ADDENDUM # 1

Bid 19C4, Urbana Elementary School Replacement – Construction Stage II

ADDENDUM NO. 1

RE: **URBANA ELEMENTARY SCHOOL REPLACEMENT**

REVISION TO SHEET A-1.3

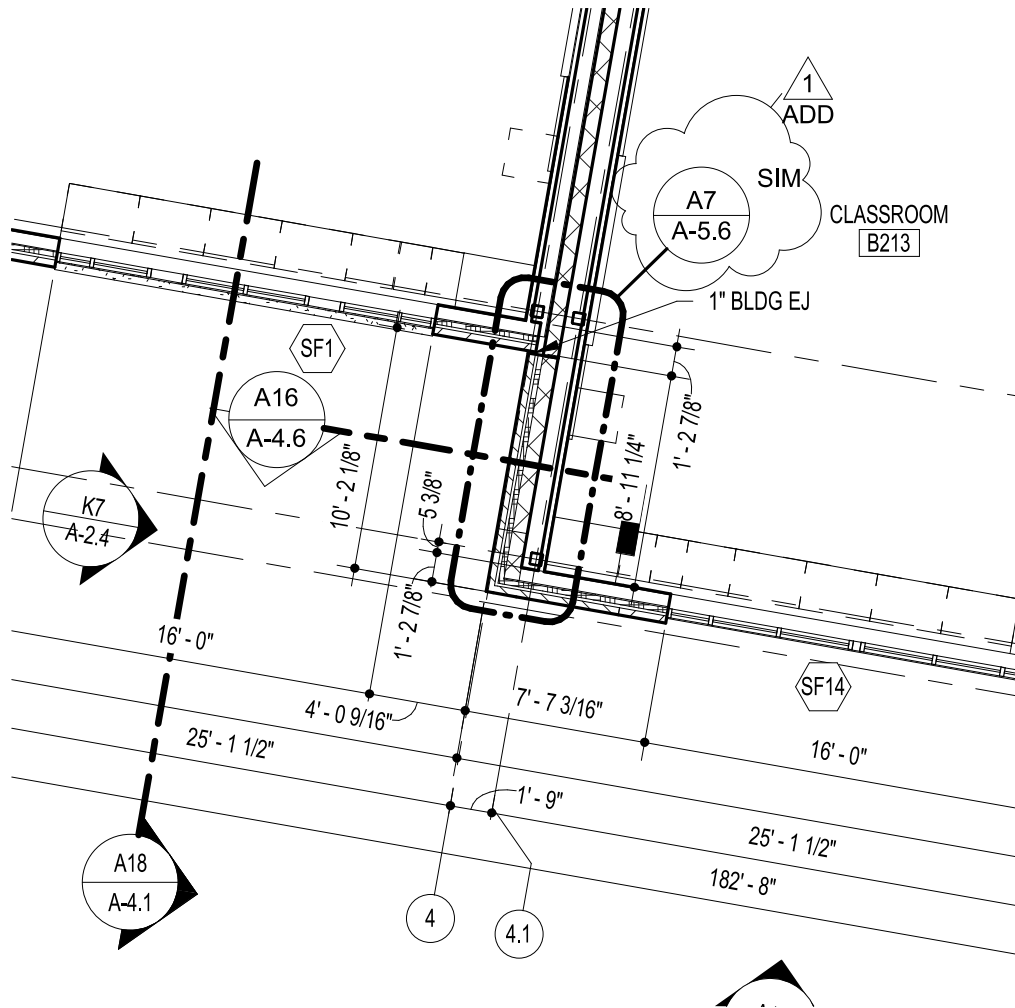
ITEM NO. A1:	<u>SHEET A-1.1</u>	<u>PARTIAL FIRST FLOOR PLAN – AREA A</u>
SUBSTITUTE	Entire sheet with sheet included with this addendum.	
ITEM NO. A2:	<u>SHEET A-1.3</u>	<u>PARTIAL FIRST FLOOR PLAN – AREA C1</u>
ADD	Dimension at screen wall per sketch SKA-1.3.1.	
ITEM NO. A3:	<u>SHEET A-1.6</u>	<u>PARTIAL SECOND FLOOR PLAN – AREA B</u>
REVISE	Plan per sketch SKA-1.6.1.	
SUBSTITUTE	Entire sheet with sheet included with this addendum.	
ITEM NO. A4:	<u>SHEET A-1.7</u>	<u>PARTIAL SECOND FLOOR PLAN – AREA C1</u>
SUBSTITUTE	Entire sheet with sheet included with this addendum.

ADD 01
SKA-1.3.1

REVISION TO SHEET A-2.2

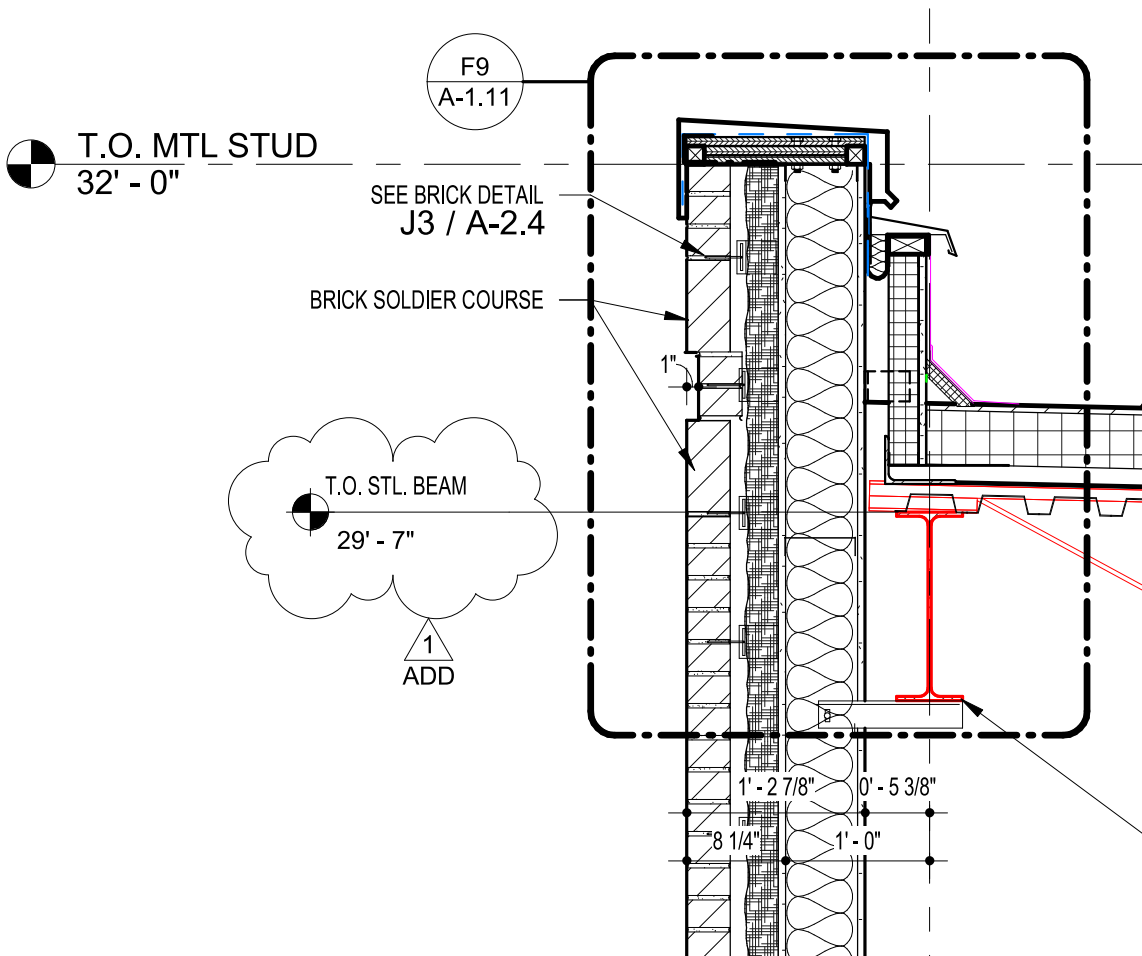
ITEM NO. A7: SUBSTITUTE	<u>SHEET A-2.1</u> <u>EXTERIOR ELEVATIONS</u> Entire sheet with sheet included with this addendum.
ITEM NO. A8: REVISE	<u>SHEET A-2.2</u> <u>EXTERIOR ELEVATIONS</u> Detail H11 per sketch SKA-2.2.1.

H11 PARTIAL EAST ELEVATION 4

REVISION TO SHEET A-4.5

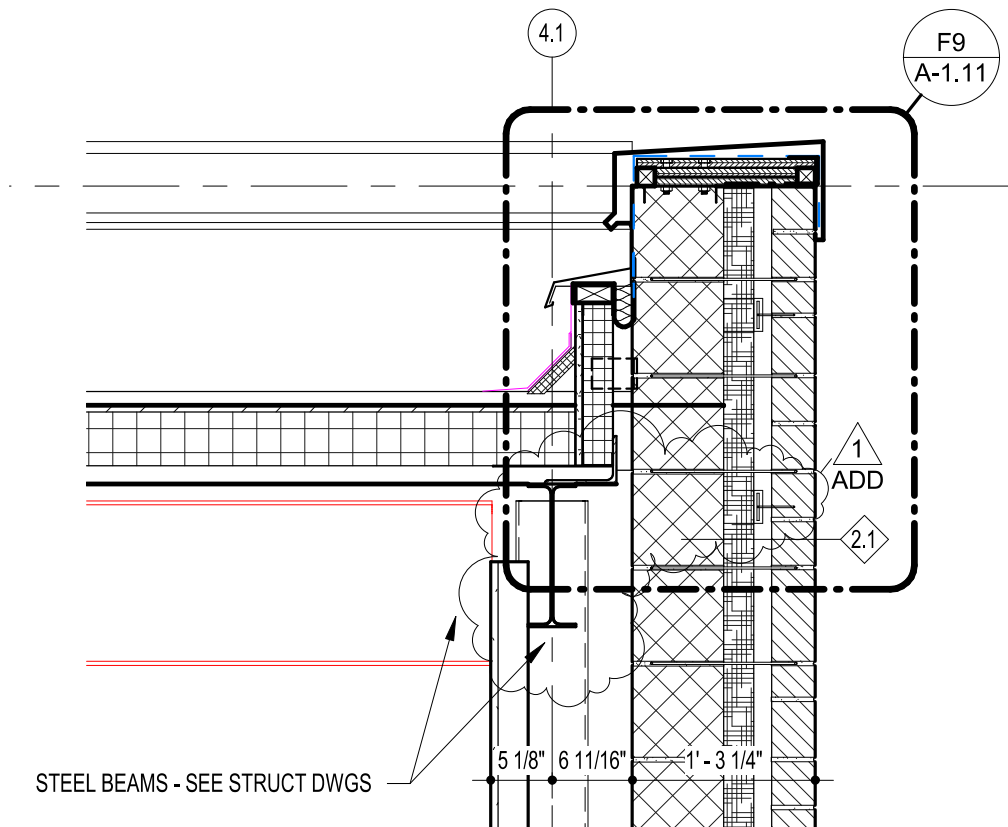
ITEM NO. A15: REVISE	<u>SHEET A-4.5</u> <u>WALL SECTIONS</u> Elevation at detail A18 per sketch SKA-4.5
ITEM NO. A16: REVISE	<u>SHEET A-4.6</u> <u>WALL SECTIONS</u> Detail A16 per sketch SKA-4.6.1.

REVISION TO SHEET M-2.7

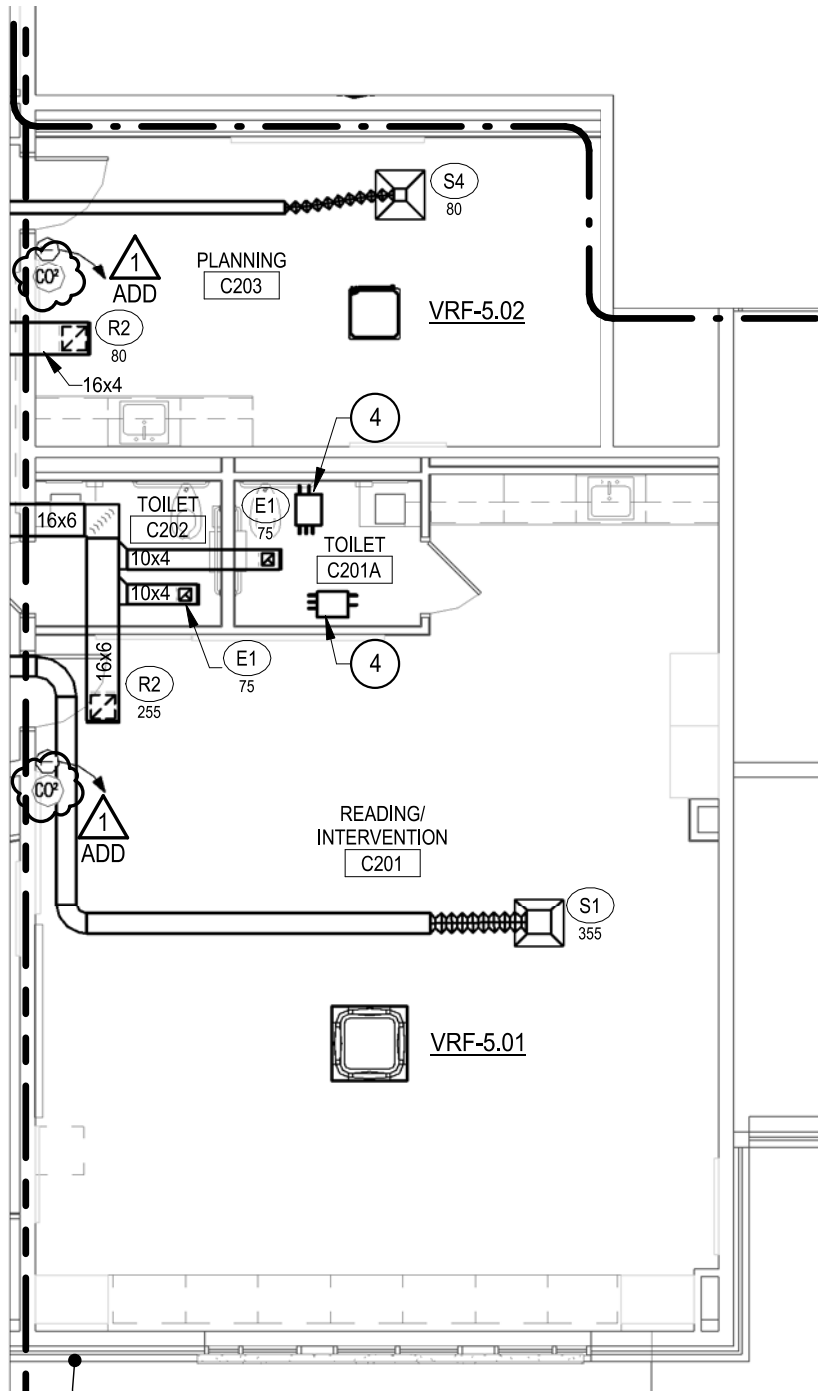
ITEM NO. M7:	<u>SHEET M-2.7</u>	<u>PARTIAL SECOND FLOOR PLAN – AREA C1</u>
ADD	CO ₂ sensors in Reading/Intervention-C201 and Planning-C203. Refer to sketch SKM-2.7.1.

REVISION TO SHEET M-2.8

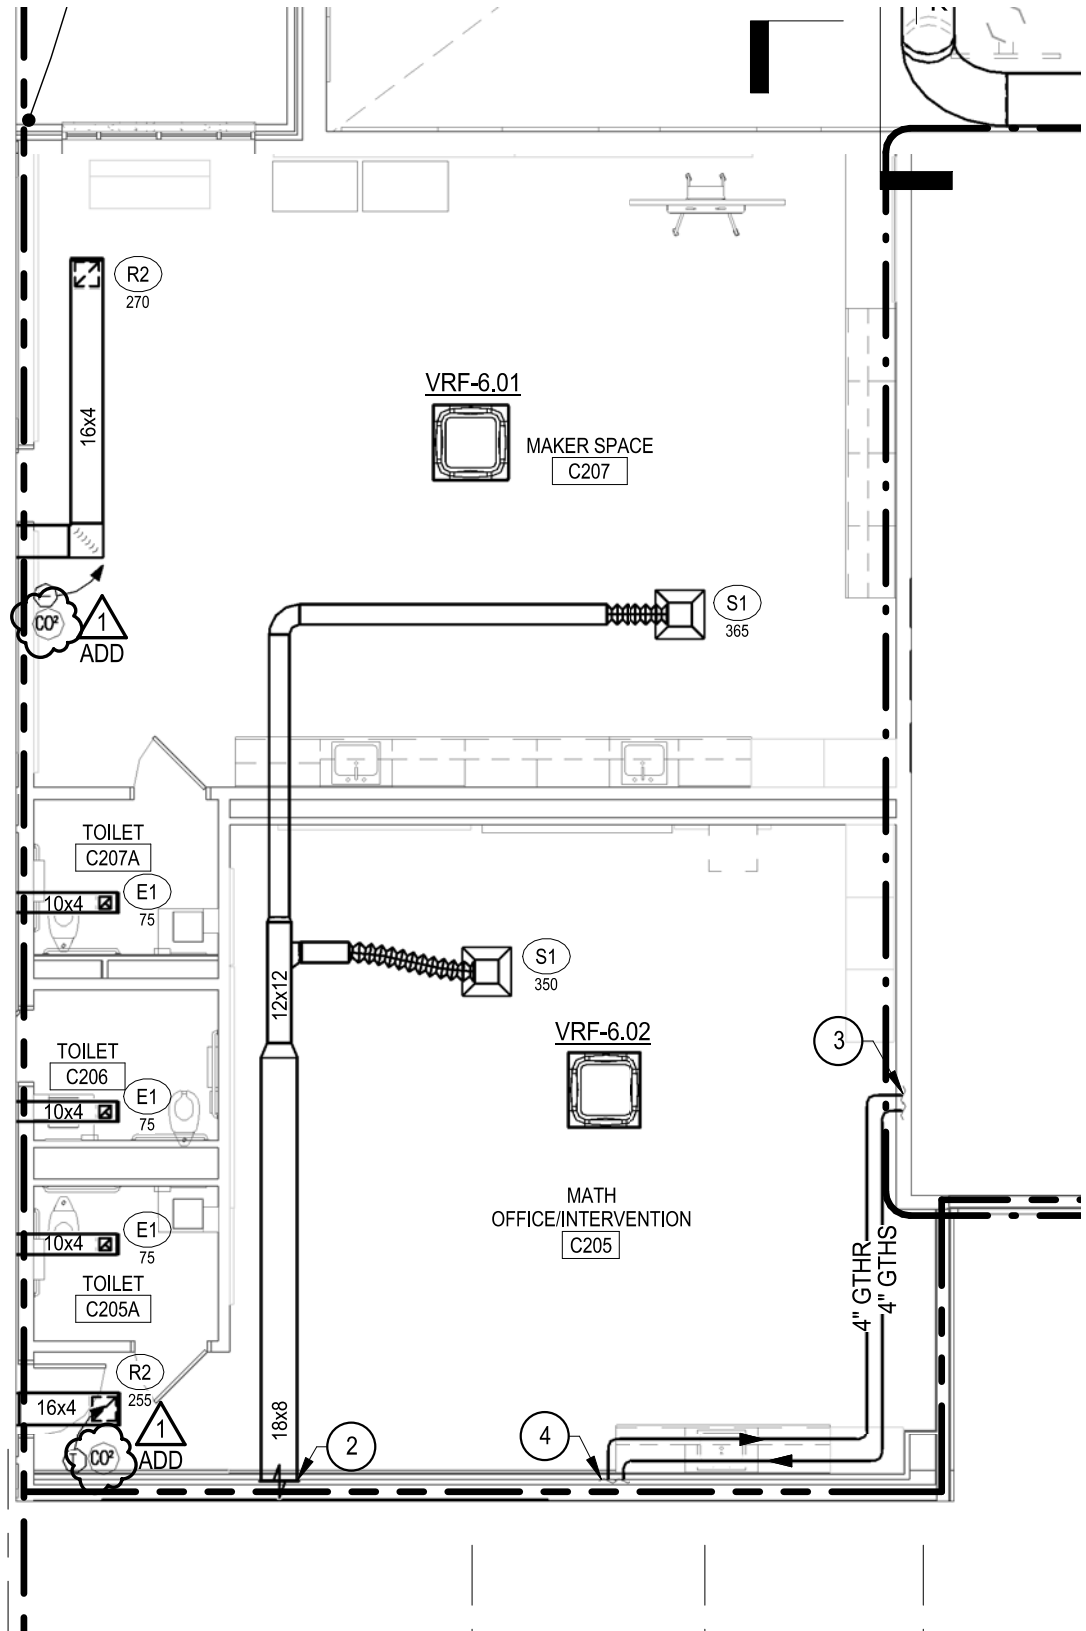
ITEM NO. M8:	<u>SHEET M-2.8</u>	<u>PARTIAL SECOND FLOOR PLAN – AREA C2</u>
ADD	CO ₂ sensors in Math Office/Intervention-C205 and Maker Space-C207. Refer to sketch SKM-2.8.1.

REVISION TO SHEET M-9.1

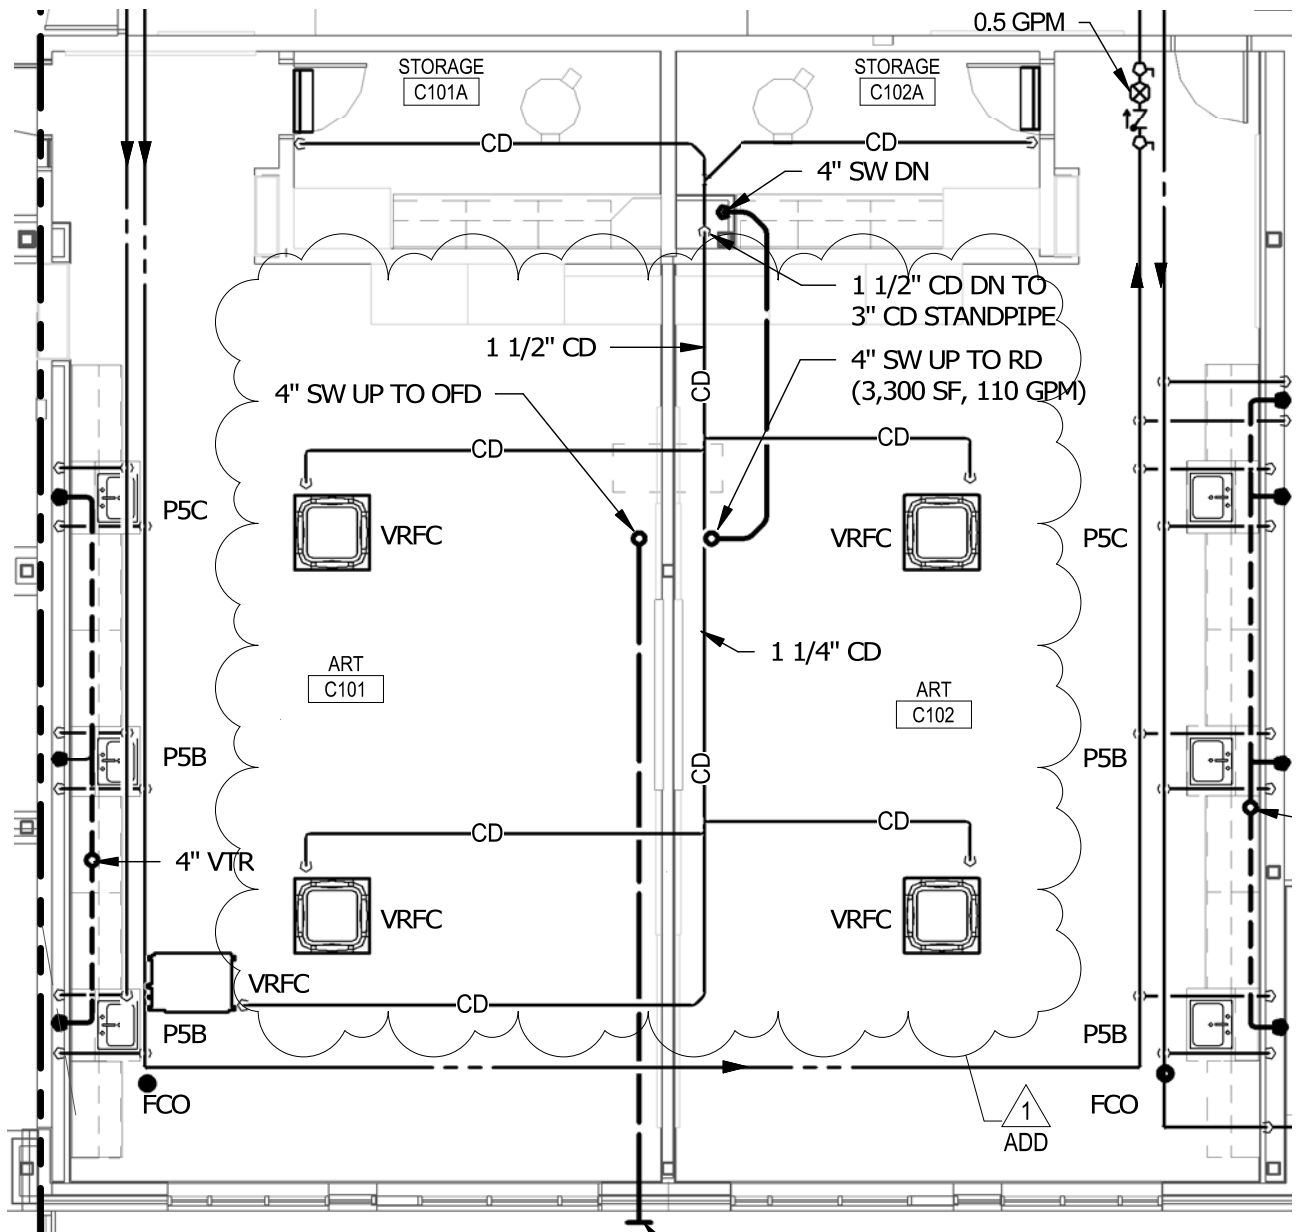
ITEM NO. M12:	<u>SHEET M-8.7</u>	<u>SECOND FLOOR PLAN – AUTOMATIC TEMPERATURE CONTROLS</u>
ADD	Entire sheet with sheet included with this addendum.	
ITEM NO. M13:	<u>SHEET M-9.1</u>	<u>MECHANICAL SCHEDULES</u>
REVISE	Minimum outside air CFM for all units on the Dedicated Outside Air System Schedule. Refer to sketch SKM-9.1.1.

E-1.1.2

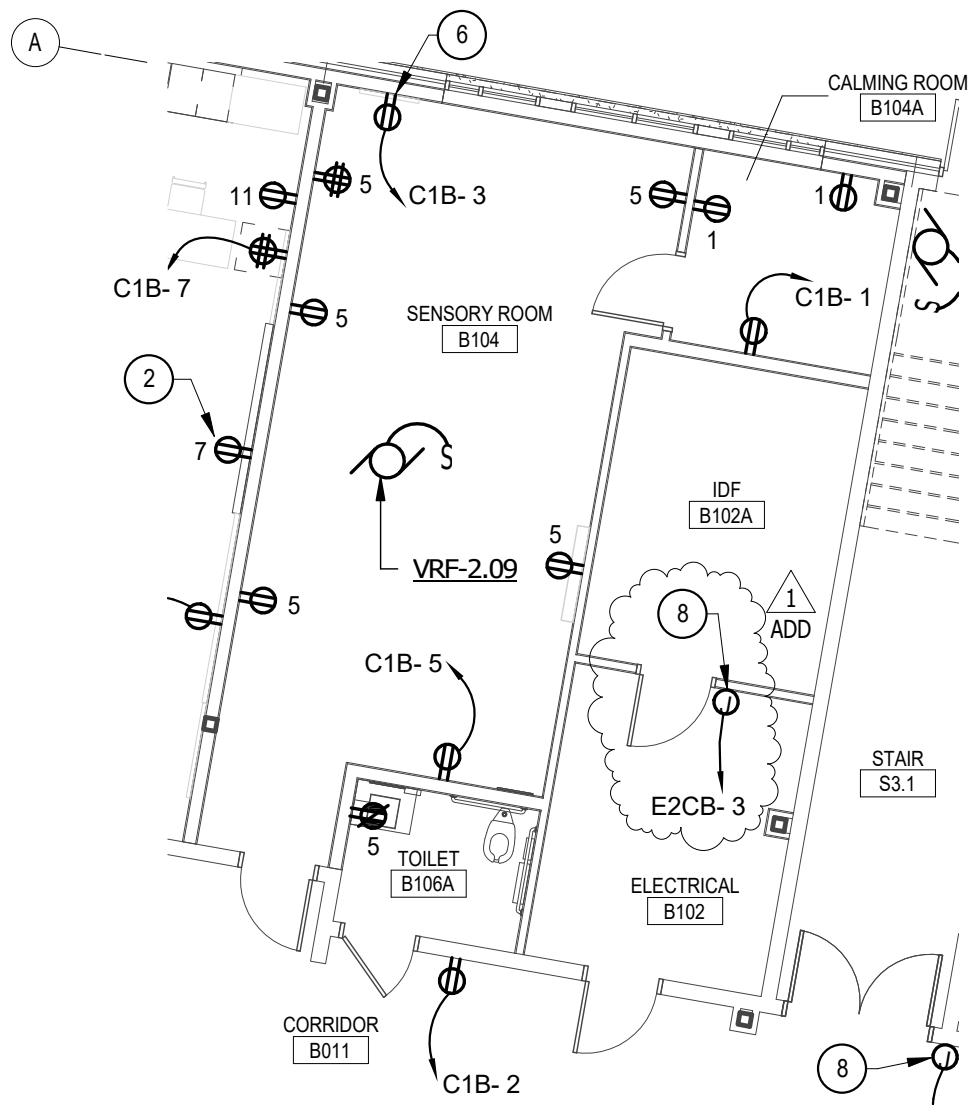
ITEM NO. E3:	<u>SHEET E-1.1</u> <u>PARTIAL FIRST FLOOR PLAN – AREA A - POWER</u>
ADD	Junction box for card reader at MDF A110B on circuit E2CA-11 with Drawing Note 10 reference. Refer to Sketch E-1.1.1 for additional information.
REVISE	Location of receptacles in Toilet A102B, Storage A102C and Health A102 per architectural revisions. Refer to Sketch E-1.1.1 for additional information.
ADD	Drawing Note 25. Refer to Sketch E-1.1.2 for additional information.
ADD	Contactor with Drawing Note 25 reference to Electrical A114A for Electric Vehicle Car Charging. Refer to Sketch E-1.1.2 for additional information.
